Technical Bulletin

Bulletin Number: 202 Revision Number: R-01

MODELS: Adaptable – 6 Select – Vend Relay Page 1 Only
Adaptable – (Red Cam) 5 Select and 6 Select – Vend Relay Page 2 Only

SUBJECT: To setup above models for Free Vend when desired.

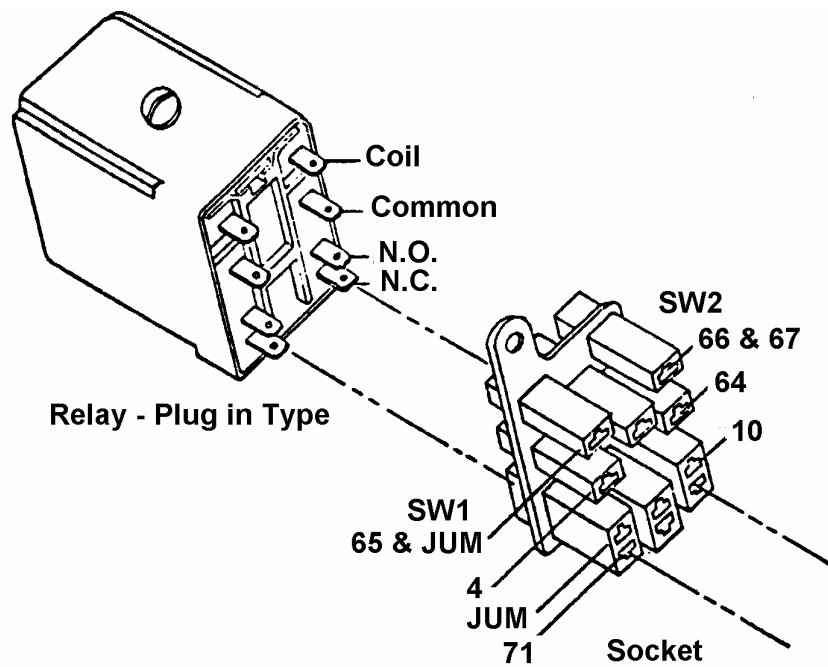
- A. Unplug the coin changer – leave it unplugged.
- B. Locate switch #1.
- C. Remove lead G37/G18 from N.C. terminal.
- D. Leave it off - - electrical tape its end.
- E. Locate switch #2.
- F. Remove lead G 11 from N.O. terminal.
- G. Attach lead G 11 to N.C. terminal, switch #1.

- A. Unplug the coin changer – leave it unplugged.
- B. Locate switch #1.
- C. Remove terminal lead 71 from N.C. socket.
- D. Leave it off - - electrical tape its end.
- E. Locate switch #2.
- *F. Remove terminal lead 10 from N.O. socket.
- *G. Insert terminal lead 10 in N.C. socket, switch #1.

- F. Changing lead 64 to lead 10.
- G. Changing lead 64 to lead 10.
